SOUTH HOLLAND DISTRICT COUNCIL

Planning Permission

Reference: H16/0435/93 Received:11-MAY-93 Type:FULL

Description: Proposed house with detached garage

SITE LAYOUT

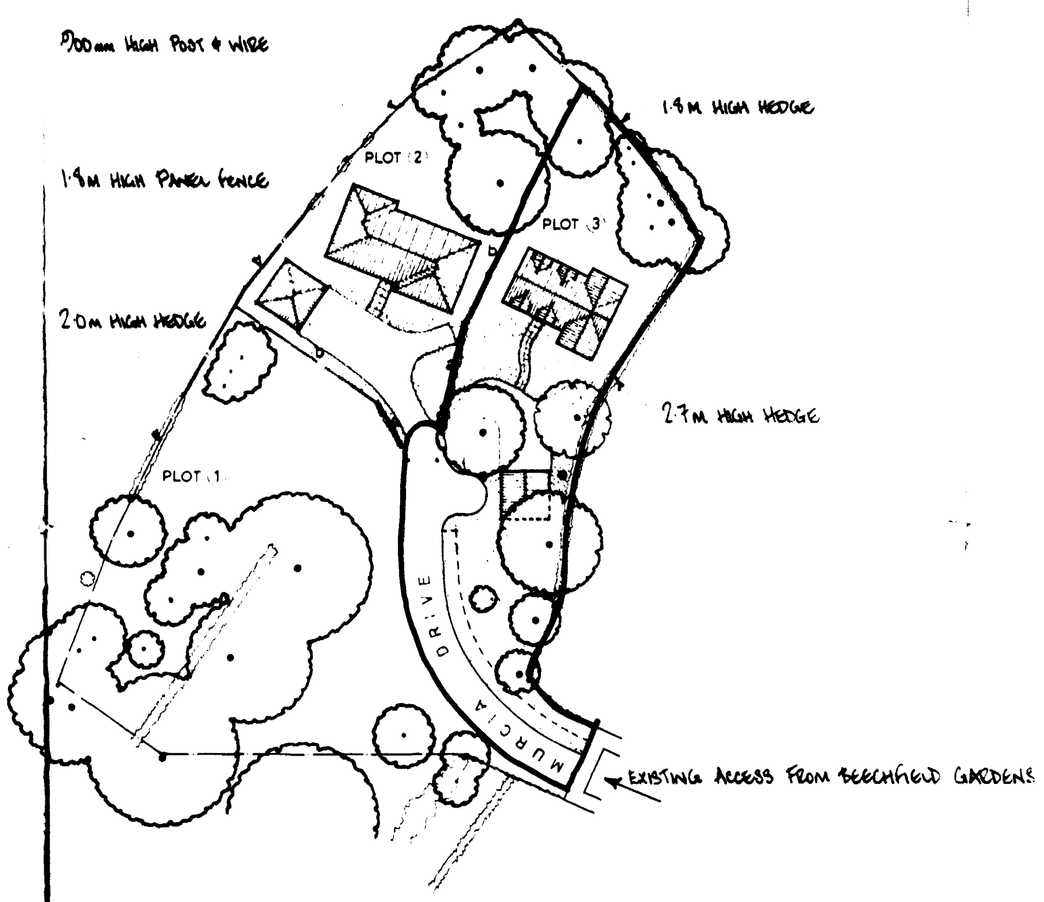
H16/0435/93 - Four trees to south east of Plot 3; one is dead and should be removed and another leans and is of a little amenity value. Other two should be pruned to remove dead wood. Weeping Beech on Plot 3 is healthy and requires no extensive work. Proposed dwelling is too close to this tree and should be moved by 2-3 metres to give acceptable clearance. Purple leaved Acer is healthy and requires no major work. Care must be taken to prevent damage when driveway constructed.

The dwelling should be repositioned so that it is at least 3 metres further away from the Weeping Beech tree. In addition the four trees to the south east of the site require some attention. According to the advice that I have received one of these trees is dead and should be removed and a Beech tree that leans could also be removed. The other two trees which are a Beech and an Ash should be pruned to remove all the wood in their crowns. I therefore advise that you contact Miss L Fairchild in order to have this work done. However, although the Local Planning Authority have been advised that the Beech tree which leans could be removed I do not guarantee that this will be permitted

ch on this plot. The dwelling therefore needs to be sited at least 4 metres further away from the tree by moving the property to the north west. The tree is also growing on a slightly raised area and the Local Planning Authority have been advised that a small retaining wall should be built around the tree so that the existing ground level can be maintained.

In addition I suggest that the boundaries of the site, in front of the building line are marked by a Beech hedge. I would be grateful for your comments for amended plans.

This plant is healthy and requires no extensive work. The proposed dwelling is too close to this tree, and I would suggest that if possible the dwelling should be re-positioned by 2 to 3 metres to give an acceptable clearance.

REVISIONS	DES.	DATE	SIGN
a.	AMENDMENTS AS REQUESTED BY PLANNING DEPT:-	20·7·93	
	1. Beech hedging to front boundaries.	"	"
	2. Plot 2, bungalow moved forward 3 metres	"	"
	3. Plot 3, house moved back 2 metres.	"	"

State details of amendments proposed
(Give a full detailed list of the changes, and also mark these clearly on the accompanying plans)
REVISED TURNING HEAD TO PRIVATE DRIVE.
